Immingham Green Energy Terminal

10.8 Proposed Further Change Application Report

Document Reference: TR030008/EXAM/10.8

Appendix 4: Traffic Regulation Measures Plan for Proposed Changes 5 – 9

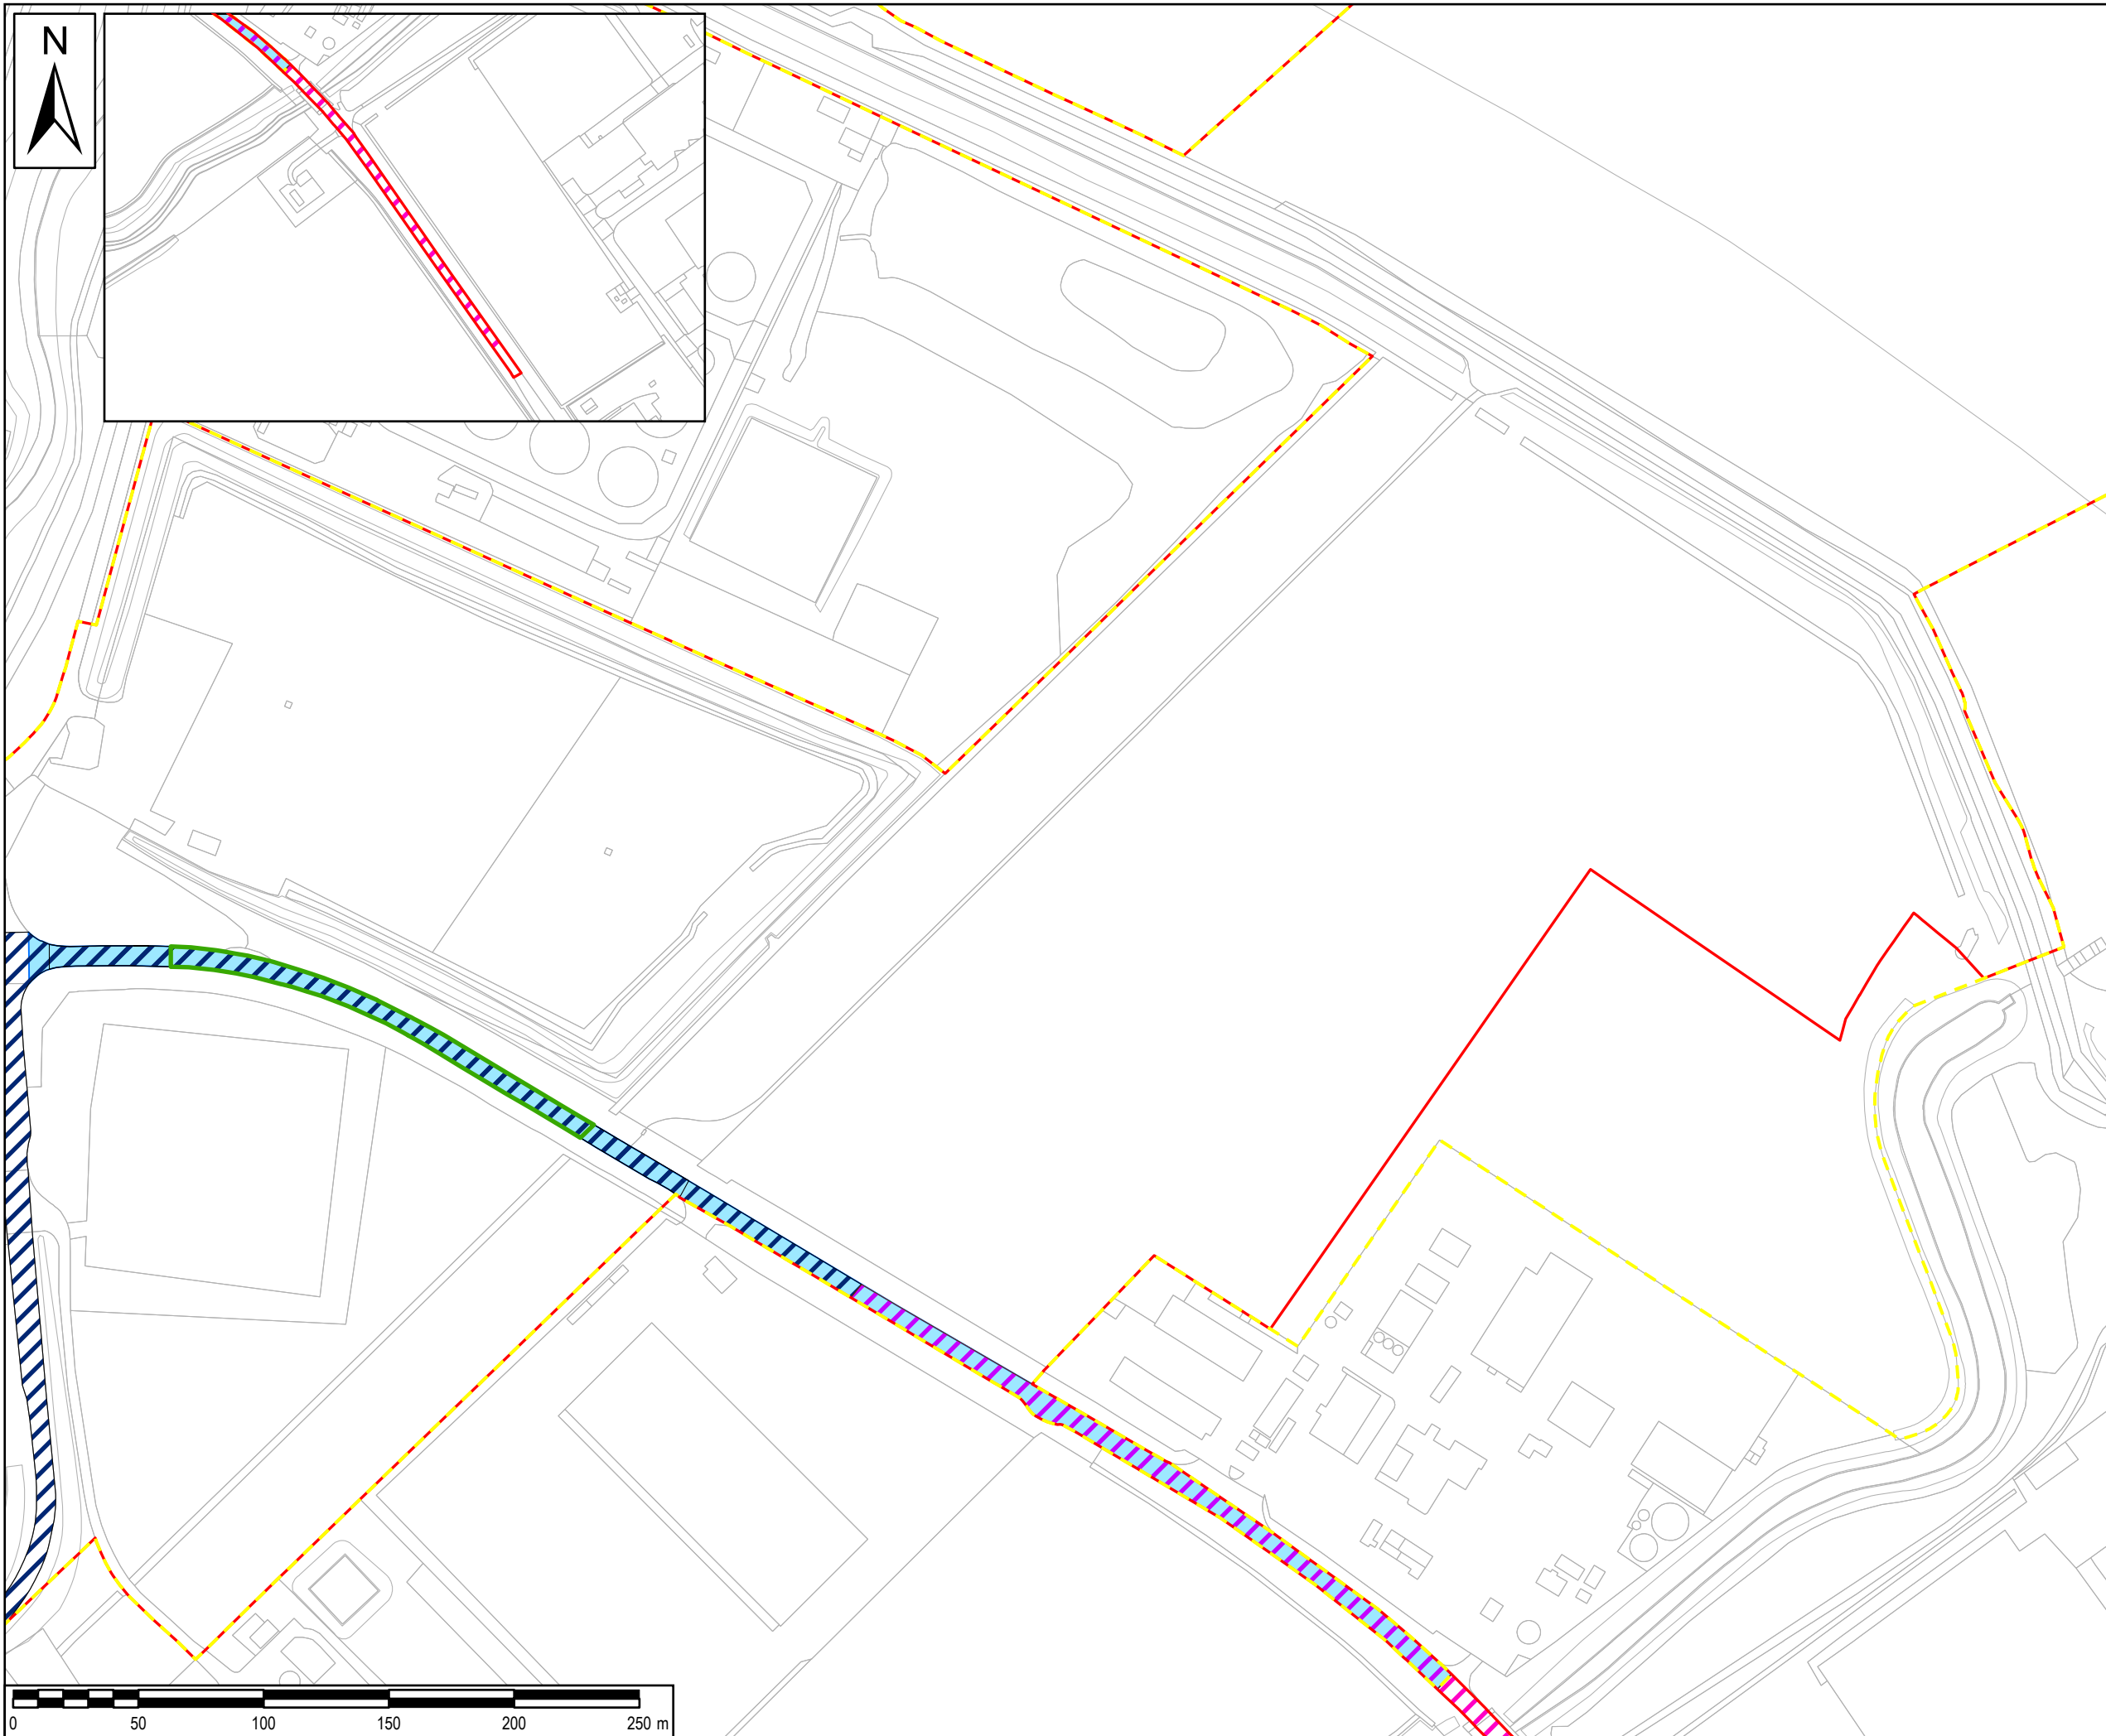
- 2.2 Proposed Change 5(a): minor changes to accesses from A1173 to Work No. 7
- 2.2.1 Proposed Change 5(a) comprises minor adjustments to the two accesses from the A1173 to Work No.7 (Access AB and Access AC as shown on the **Street Works and Accesses Plan [TR030008/APP/4.6(3)]**). **Appendix 1** identifies the location of this proposed change and **Appendix 3** illustrates the details of the proposed change.

proposals and, as a result, minor adjustments to the final shape of the polygons for Access AB and Access AC (from those shown on the indicative plans contained in the PFCNR) have been made. These adjustments (resulting in slightly larger polygons) are to provide more flexibility at the detailed design stage so as to ensure that the final design of the access and consequential alignment changes to the cycleway can be accommodated. The minor nature and scale of these adjustments do not result in any change to the assessments contained in the PFCNR. **Appendix 2** has been updated (from that contained in the PFCNR) to show the final proposed polygons. The **Street Works and Accesses Plan [TR030008/APP/4.6(3)]** and the **Stopping Up and Restriction of Use of Streets and Public Rights of Way Plan [TR030008/APP/4.7(3)]** contain the final proposed polygons.

- 2.3.2 **Appendix 1** identifies the location of this proposed change and **Appendix 3** illustrates the details of the proposed change.
 - 2.3.3 The need for this change results from engagement with NELC Highways on the detailed design of the retained verges and visibility splays. As a result, there would be a minor (beneficial) reduction of the extent of Work No. 3 of approximately 19.45 m² to exclude the area that would remain public highway and adjust the Work No. 3 boundary accordingly.

NELC Highways. As a result, there would be a minor (beneficial) reduction in Work No. 7. **Appendix 1** illustrates the location of the proposed change and **Appendix 3** illustrates the proposed area of stopping up.

2.5.4 The implementation of this Proposed Change 6 would involve updates to the **Stopping Up and Restriction of Use of Streets and Public Rights of Way (PRoW) Plan [TR030008/APP/4.7(3)]** and details of the area of permanent stopping up would be included in Schedule 6 of the **dDCO [TR030008/APP/2.1(6)]**. There would also be associated alterations to the **Works Plans [TR030008/APP/4.2(4)]** to reflect the minor reduction in Work No. 7 and to the **Land Plans [TR030008/APP/4.5(3)]** and the **Book of Reference [TR030008/APP/3.1(3)]** to identify a new plot 7/24 (previously forming part of plot 7/13) which is the proposed area of stopping up, and a slight enlargement of plot 7/12 (which is highway land) to reflect the revised highway boundary.

Figure 1: Proposed Piling Rig Programme and Locations

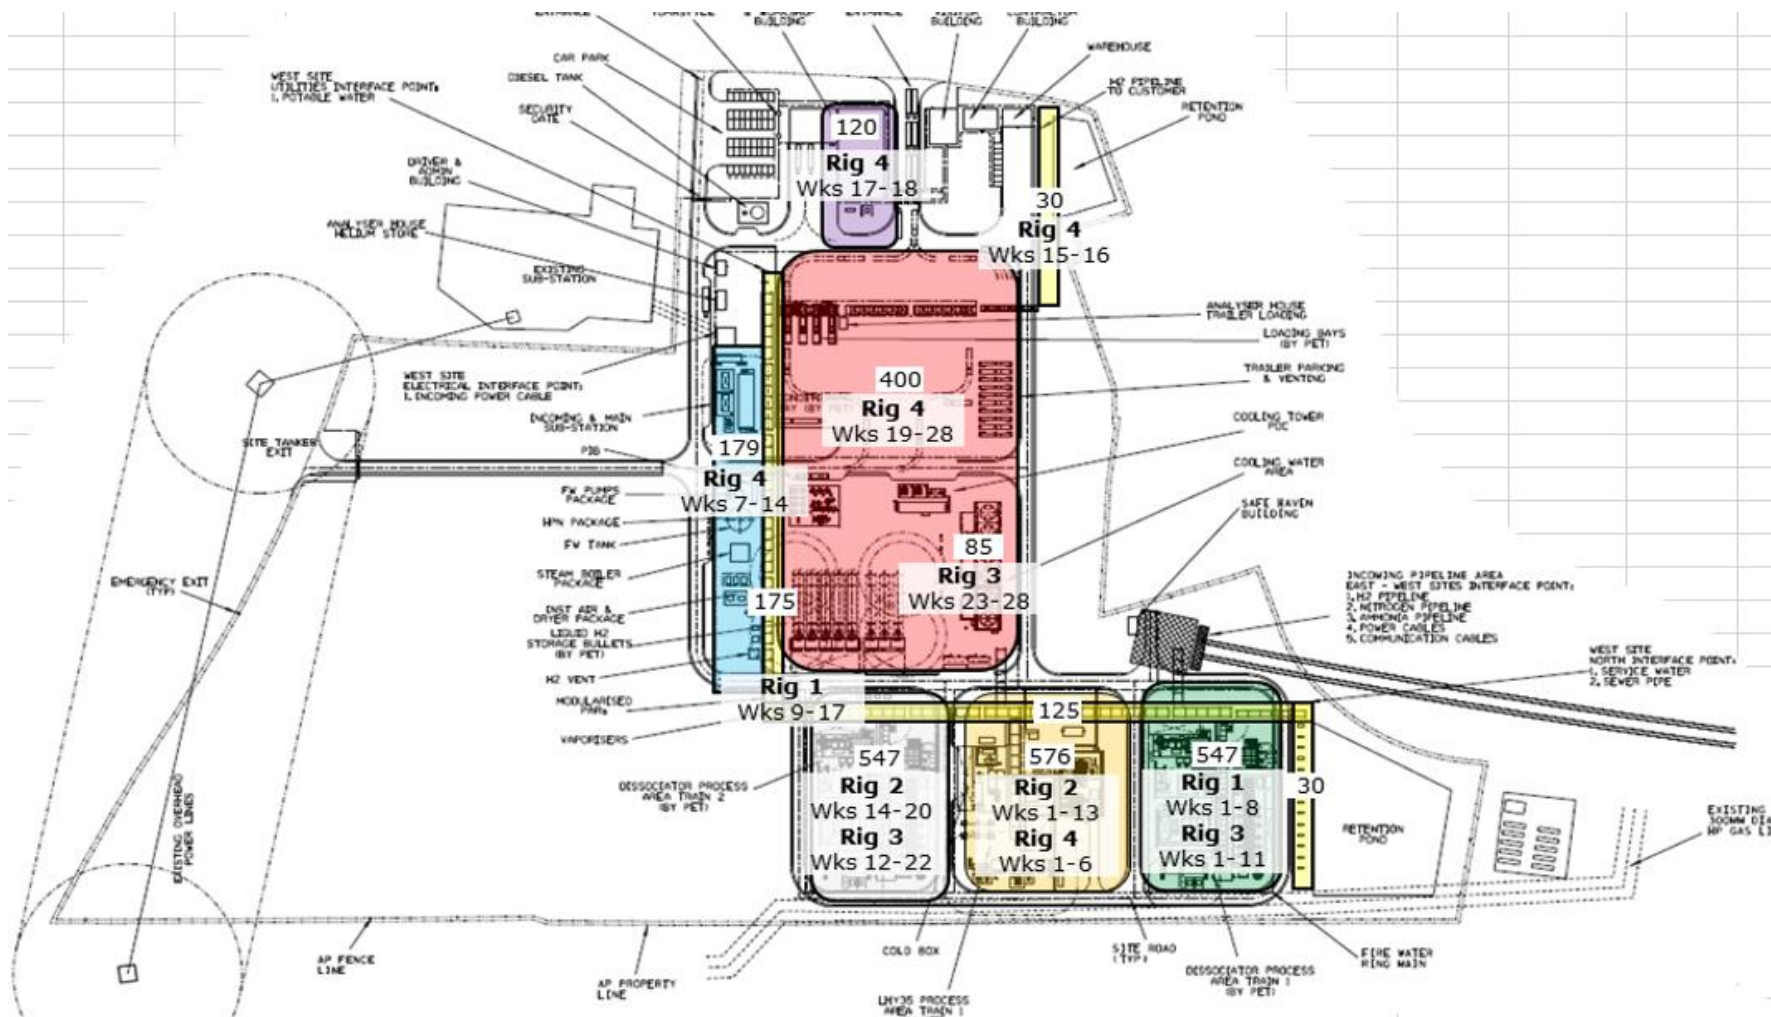
- For Work No. 7 the location of the piling rigs is based on **Figure 1** below, with the worst-case scenario for each NSR based on weeks during which the piling rigs are the closest to the NSR, as follows:

- NSR 3 and 4 - Weeks 12-14 (Rig 1 in operation in the pale yellow linear areas, Rigs 2 and 3 in operation in the white/pale grey area and Rig 4 in operation in the blue area)
